POND 1  
FINAL ASBUILT  
FIELD DATA COMPLETED 5-17-23

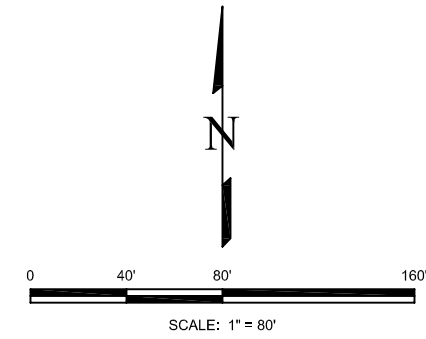
Please include a legend for linework on all field as-built drawings. Identify if the green lines are design or as-built contours.

Please show design elevations and as-built elevations on all field as-built drawings.

These are as-built drawings provided by the surveyor. Only as-built contours are shown. All linework is labeled.

Addressed  
Please label contours

These are as-built drawings provided by the surveyor, a note has been added clarifying that these show the as-built conditions only. Please see our "as-built plans" which include both the design condition and as-built condition.

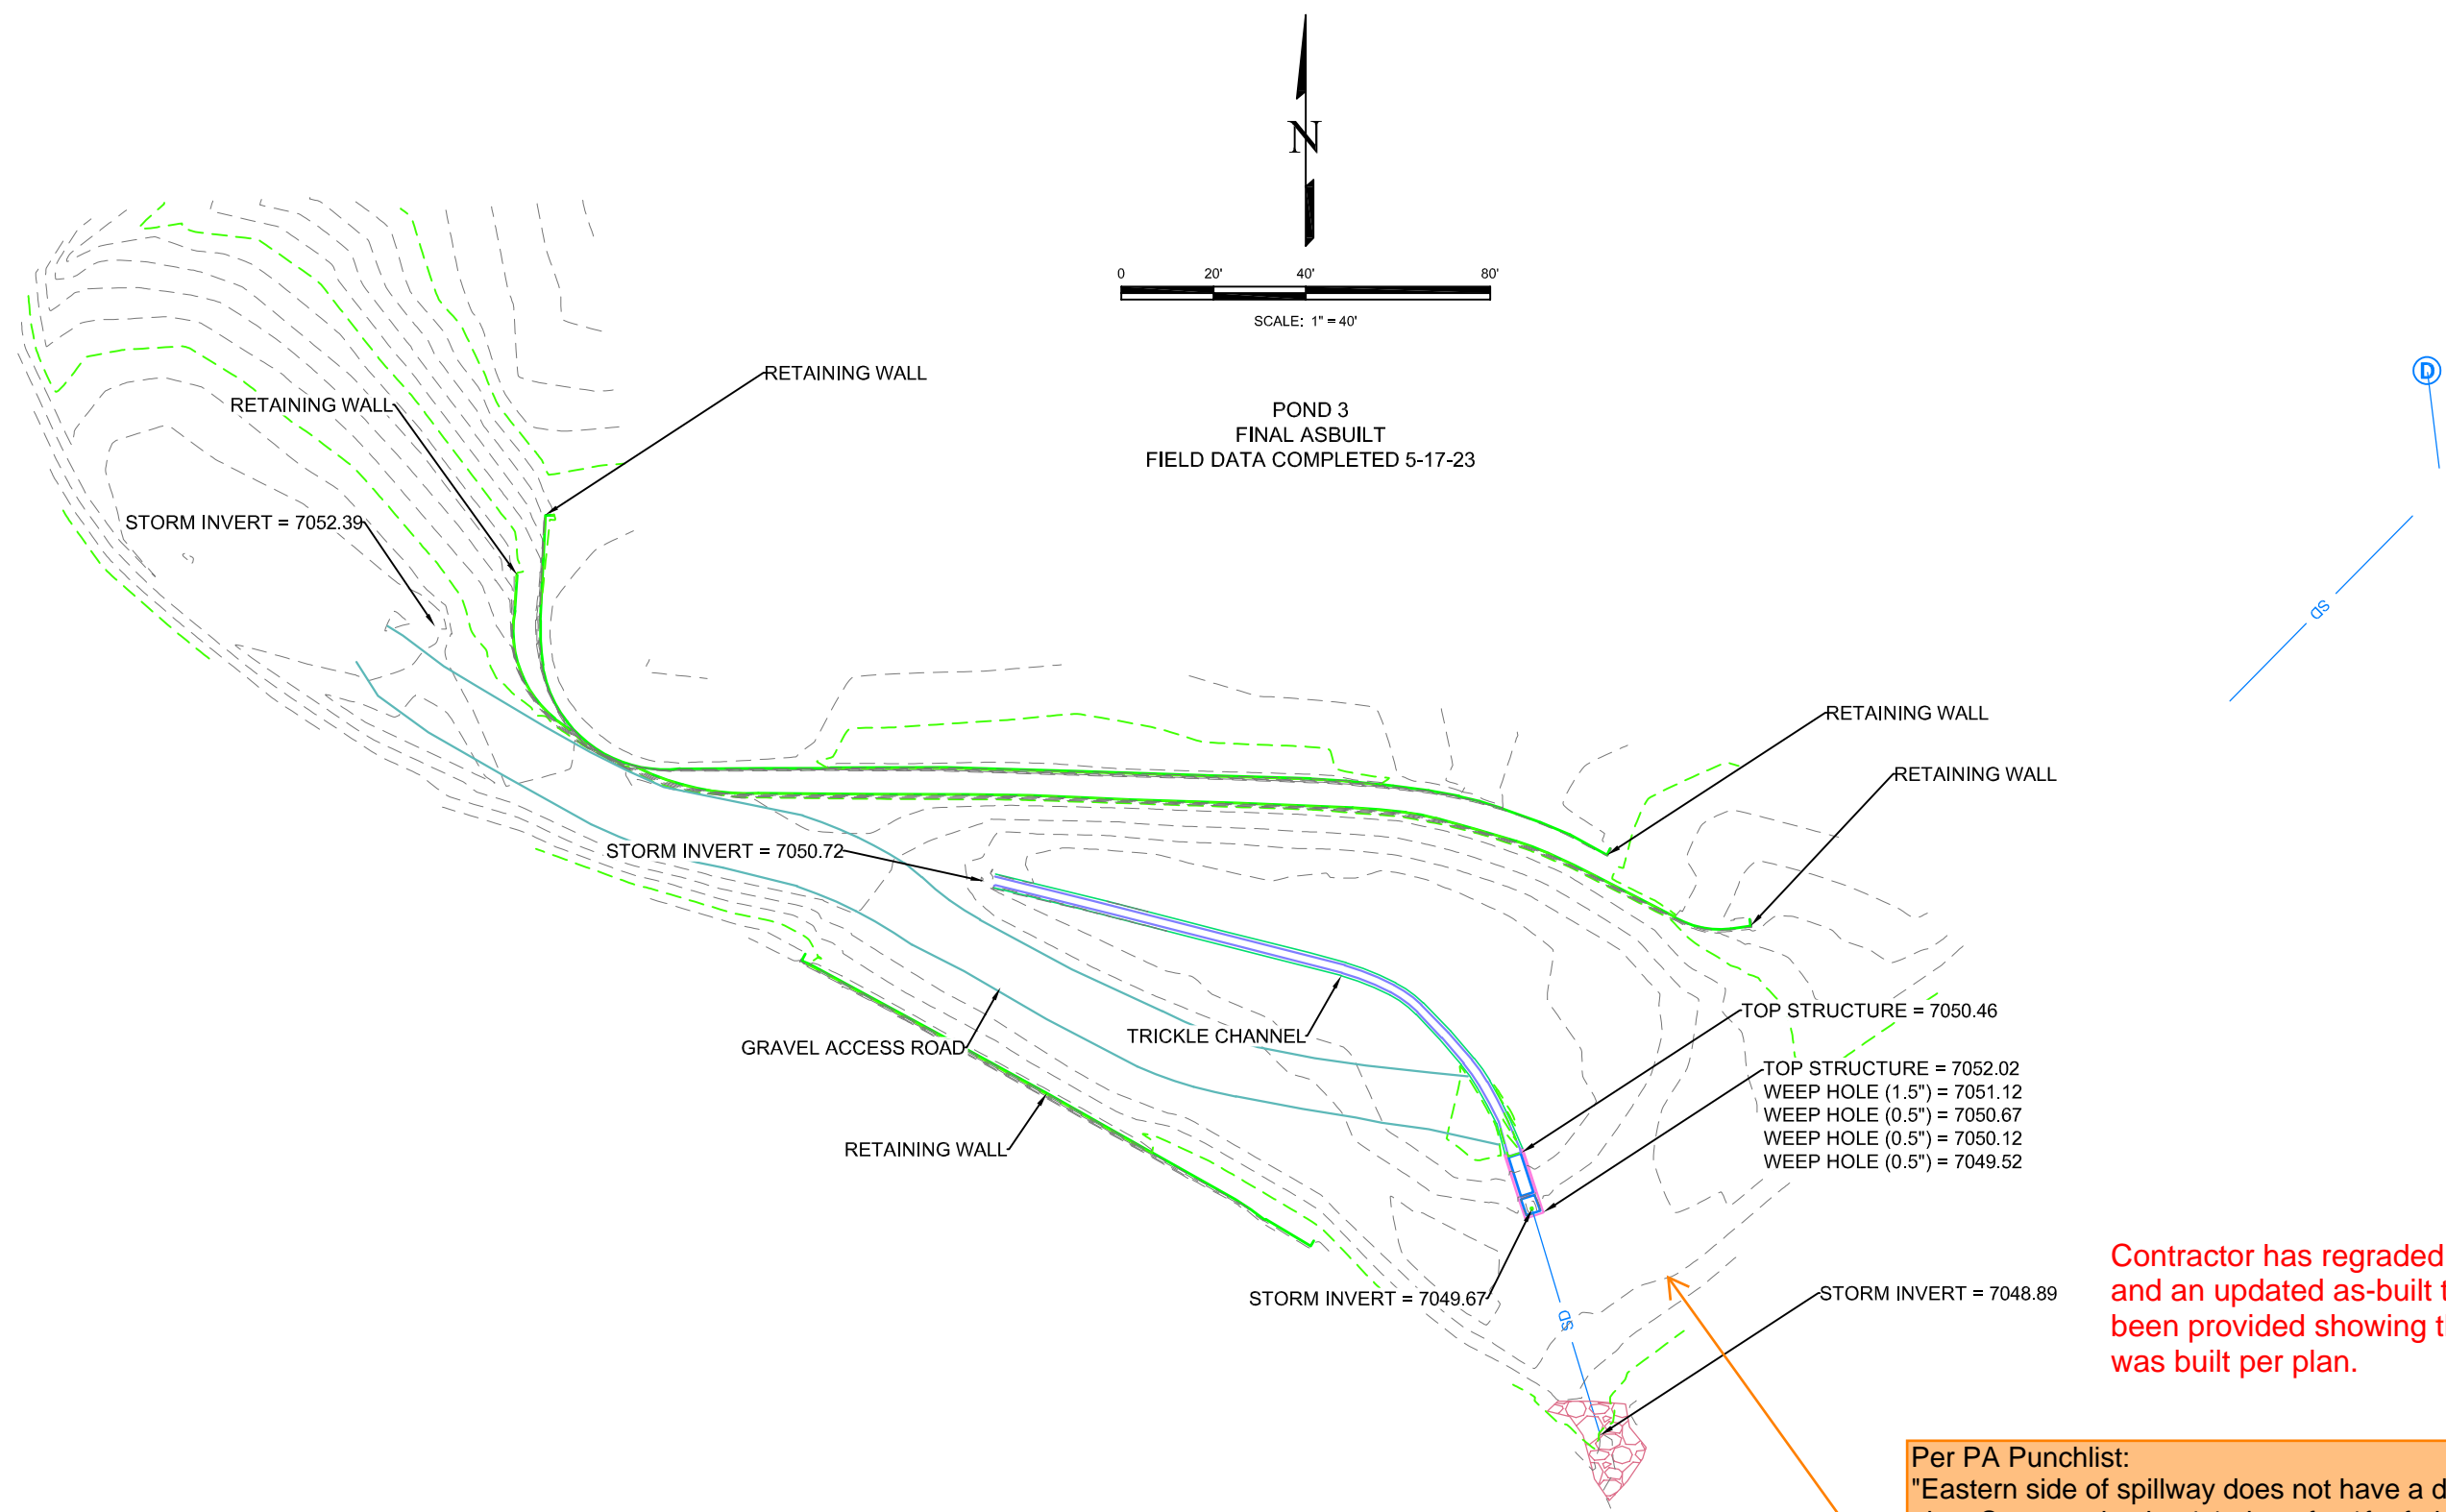
Per PA Punchlist:  
"Eastern side of spillway does not have a discernible embankment per plan. Supposed to be 4:1 slope for 1ft of elevation. Elevations of spillway crest or embankment likely not built per plan. Construct per plan."  
Or come up with a suitable alternative spillway design that is at an acceptable depth and properly armored.

Contractor has regraded this area, and an updated as-built topo file has been provided showing the spillway was built per plan.

POND 4  
FINAL ASBUILT  
FIELD DATA COMPLETED 5-17-23

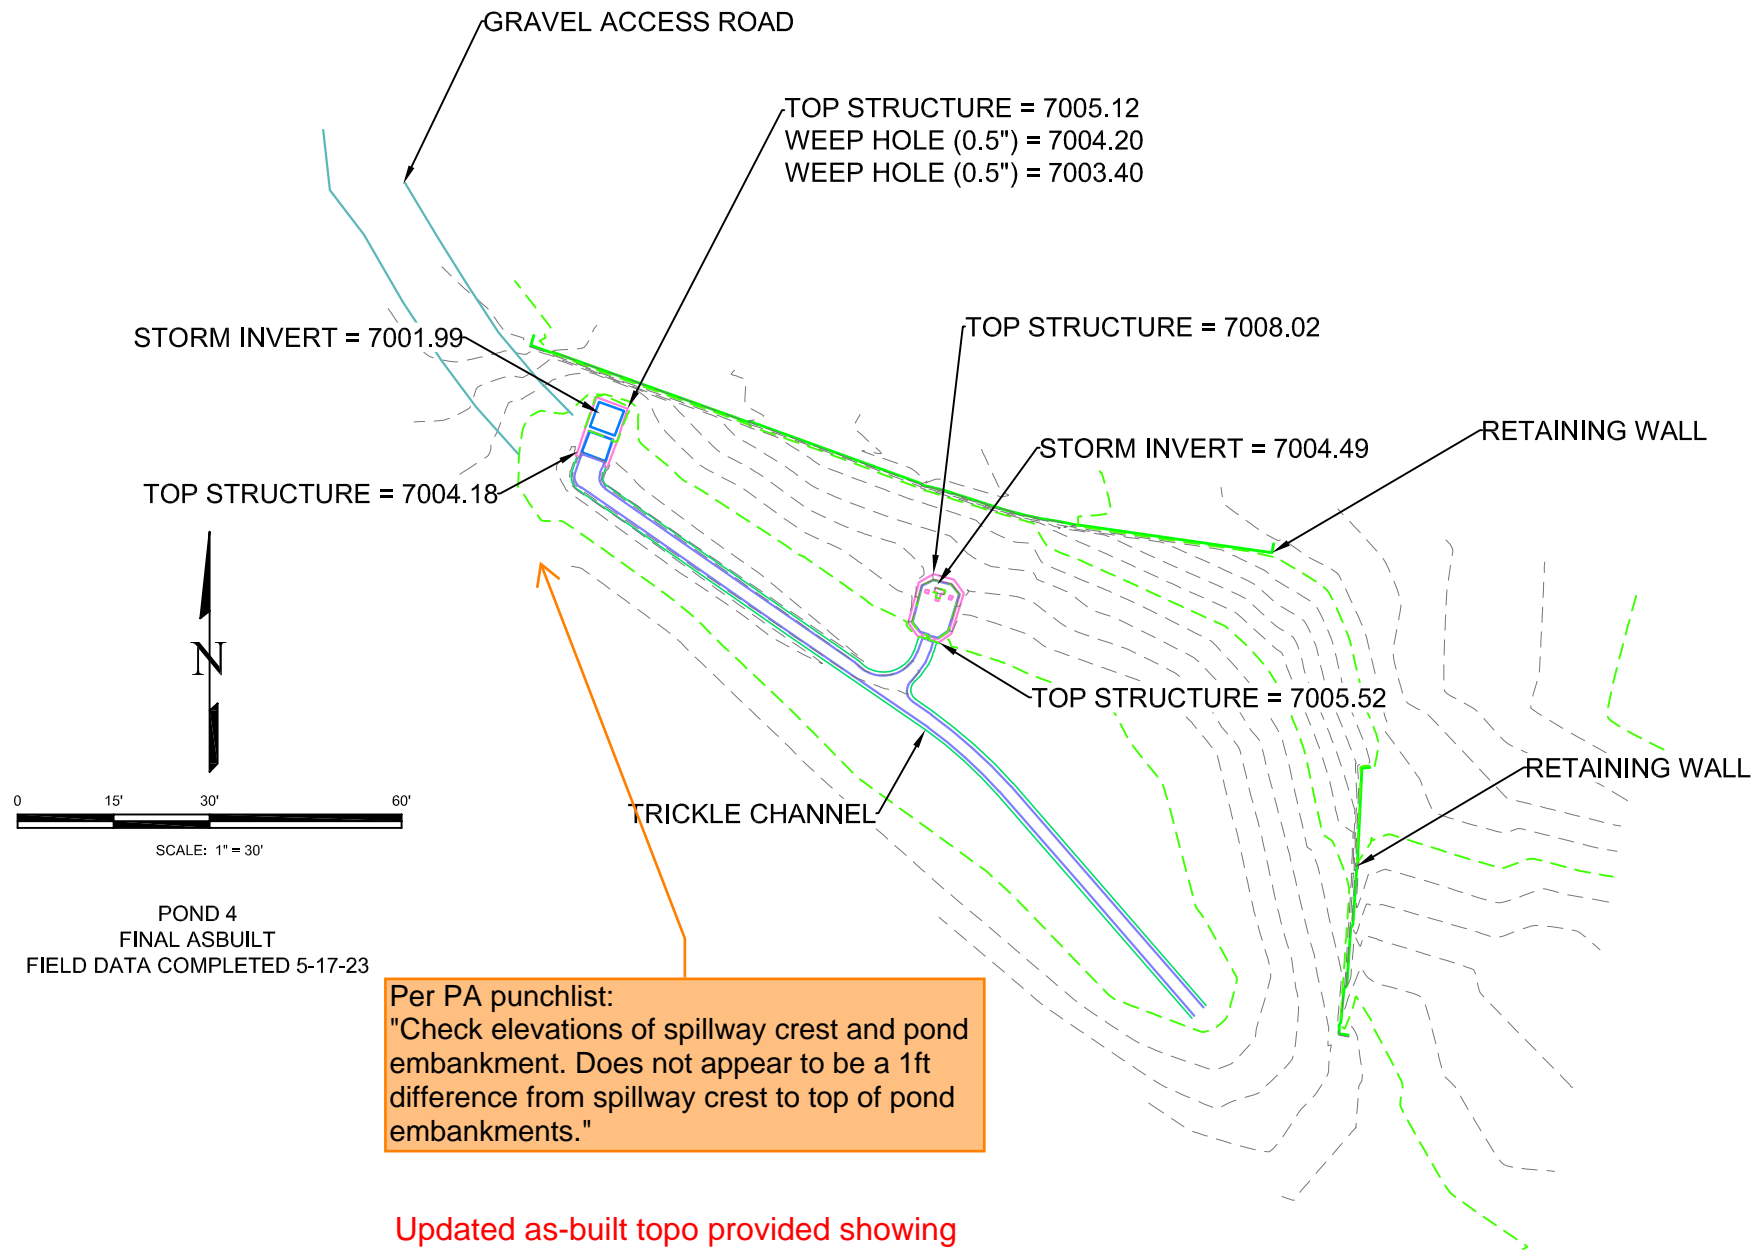
Per PA punchlist:  
"Check elevations of spillway crest and pond embankment. Does not appear to be a 1ft difference from spillway crest to top of pond embankments."

Updated as-built topo provided showing more than a foot between top of pond and spillway crest after contractor regraded this area to plan.
